ACCESSION NBR: 8310170446 DOC. DATE: 83/09/29 NOTARIZED: NO DOCKET #
 FACIL: 50-397 WPPSS Nuclear Project, Unit 2, Washington Public Powe 05000397
 AUTH. NAME: SORENSEN, G.C. AUTHOR AFFILIATION: Washington Public Power Supply System
 RECIP. NAME: SCHWENCER, A. RECIPIENT AFFILIATION: Licensing Branch 2

SUBJECT: Discusses history & background of use of fire dampers not fire rated or tested in const of facility, due to state of art const at time of installation, FSAR will be revised via Amend 33 to document const, Marked-up drawings encl.

Subject: NUCLEAR PROJECT NO. 2
FIRE DAMPER QUALIFICATION

BURNS AND ROE, INC. ENGINEERS AND ARCHITECTS SAN FRANCISCO, CALIF.	
GENERAL ARRANGEMENT PLANS & SECTIONS CIRCULATING WATER PUMP HOUSE	
WASHINGTON PUBLIC POWER SUPPLY SYSTEM SANFORD No. 2	
DATE	10/1/58
BY	J. H. ROE
CHECKED BY	J. H. ROE
APPROVED BY	J. H. ROE
W.D. 2808

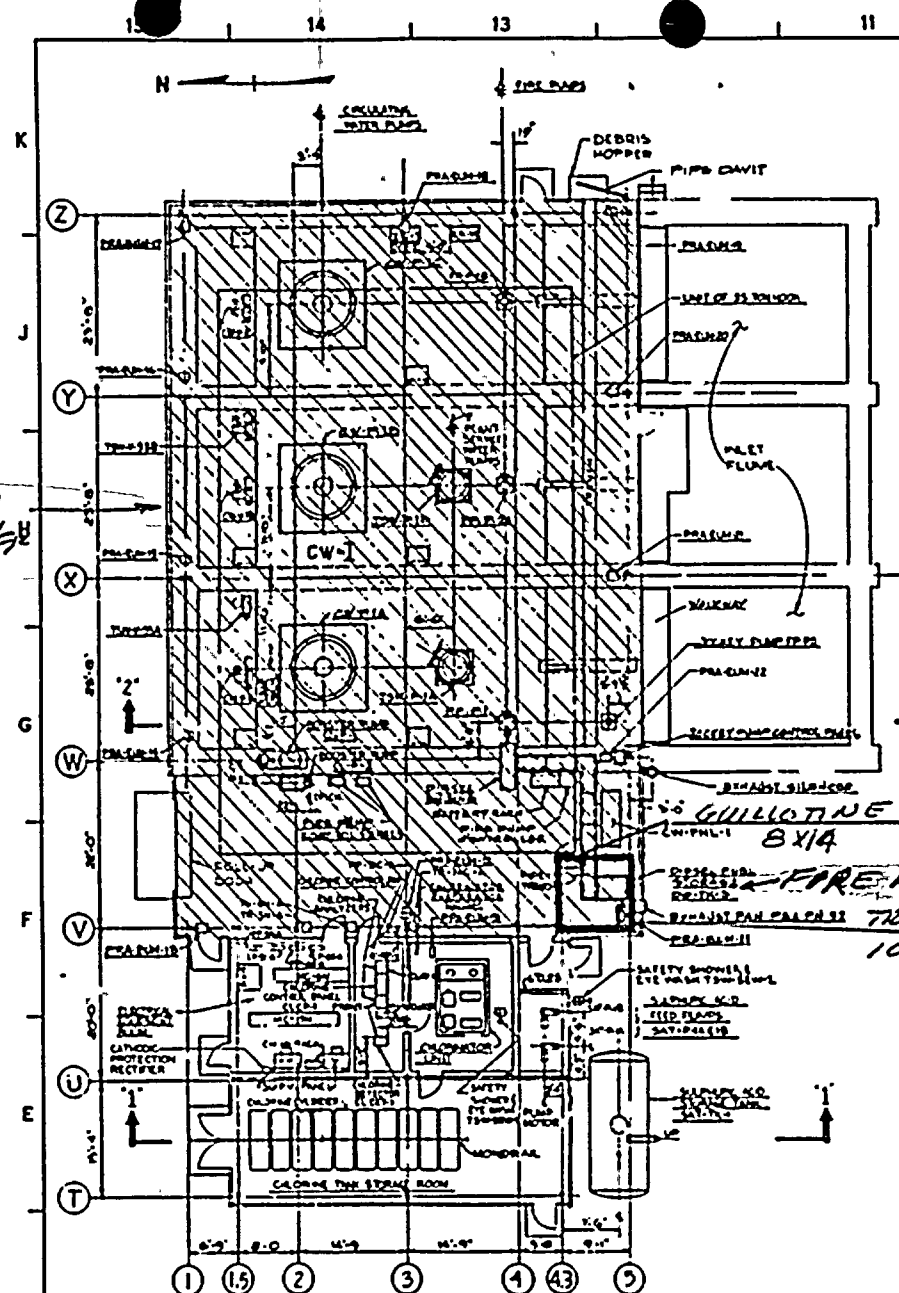
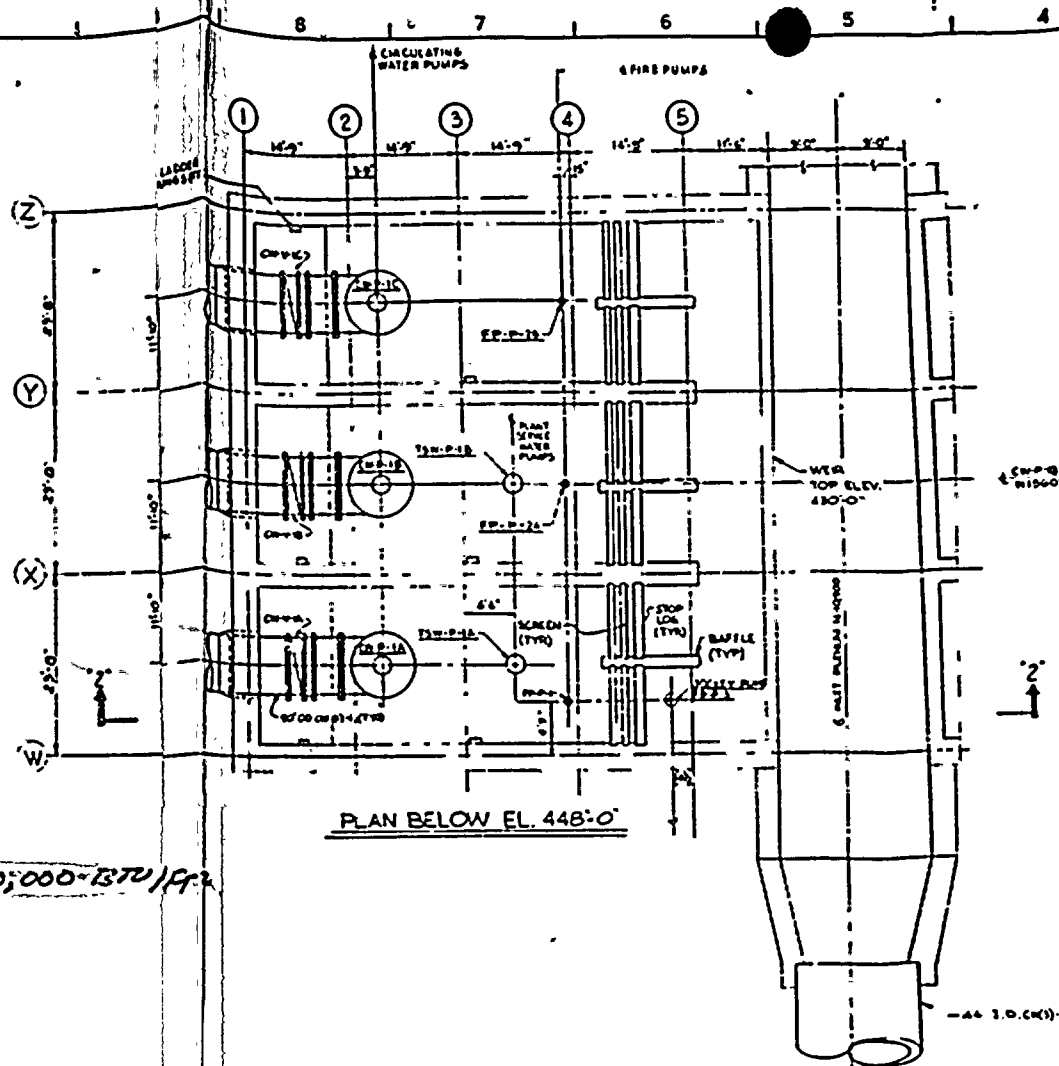
Attachment 3 shows the location and size of the dampers and the fire loading in each area involved. The location of the dampers are noted in red. The guillotine dampers are attached using through bolting on hollow block walls and expansion bolts on concrete walls.

FIRE LOAD
6980 BTU/FT²
